PROPOSED CHANGE RTS-197A TO THE DUANE ARNOLD ENERGY CENTER
TECHNICAL SPECIFICATIONS

The holders of license DPR-49, for the Duane Arnold Energy Center propose to amend Appendix A (Technical Specifications) to said license by deleting certain current pages and replacing them with the attached, new pages. The List of Affected Pages is given below.

Figure 3.6-1: Pressure Versus Minimum Temperature Valid to Sixteen Full Power Years, per Appendix G of 10CFR50

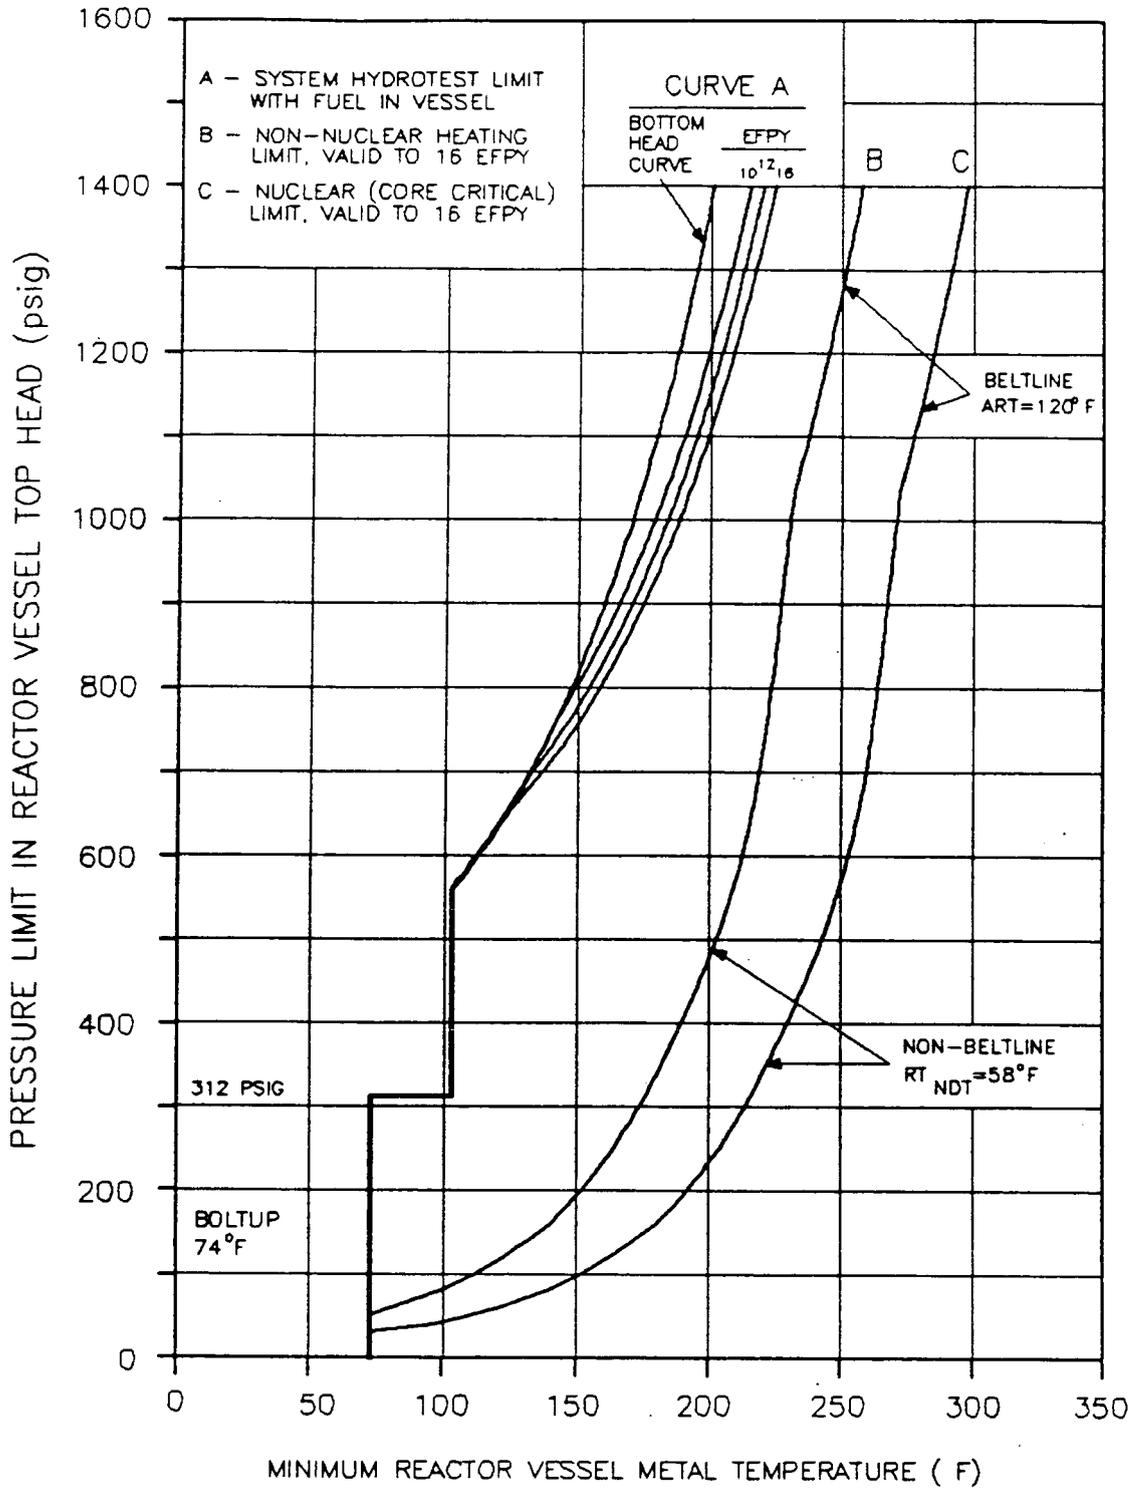
The existing LCO is being revised as follows:
"The reactor vessel shall be vented and power operation shall not be conducted unless the reactor vessel temperature is equal to or

greater than that shown in Curve C ~~or~~ of Figure 3.6-1. Operation for hydrostatic or leakage tests, during heatup or cooldown, and with the core critical shall be conducted only when vessel temperature is equal to or above that shown in the appropriate curve of Figure 3.6-1. ~~Figure 3.6-1 is effective through 16 effective full power years. At least six months prior to 16 effective full power years new curves will be submitted.~~"

This LCO currently contains a statement, "Figure 3.6-1 is effective through 16 effective full power years. At least six months prior to 16 effective full power years new curves will be submitted."

- a) This statement is a commitment and not an LCO. This statement does not contain information relative to the immediate operation of the plant or the mitigation of any accident. Information of this nature is typically located in the Bases Section and/or in a commitment tracking system. DAEC is proposing to revise the Bases Section to contain this information.

- b) NRC Generic Letter (GL) 91-01, "REMOVAL OF THE SCHEDULE FOR THE WITHDRAWAL OF REACTOR VESSEL MATERIAL SPECIMENS FROM TECHNICAL SPECIFICATIONS" provides guidance for the removal of the specimen schedule and associated language from the TS. The justification for removal is that the TS requirement is a duplication of 10CFR50, Appendix H. The GL also provides that the licensee state in the TS that the specimens be withdrawn in accordance with 10CFR50, Appendix H. The proposed DAEC SR 4.6.A.2 has been revised to comply with the GL. As stated in the GL, the removal of the schedule and language associated with the schedule will not result in any loss of regulatory control.

"The reactor vessel material specimens shall be removed and examined to determine reactor pressure vessel fluence as a function of time and THERMAL POWER as required by 10CFR50, Appendix H. The results of these fluence determinations shall be used to update Figure 3.6-1."

The added paragraph simply states that the specimens will be removed and examined in accordance with 10CFR50, Appendix H and that the results of the fluence determinations will be used to update Figure 3.6-1, "Pressure Limit in Reactor Vessel Top Head versus Minimum Reactor Vessel Metal Temperature." This proposal is consistent with the NRC Generic Letter 91-01 and the guidance provided by Standard TS.
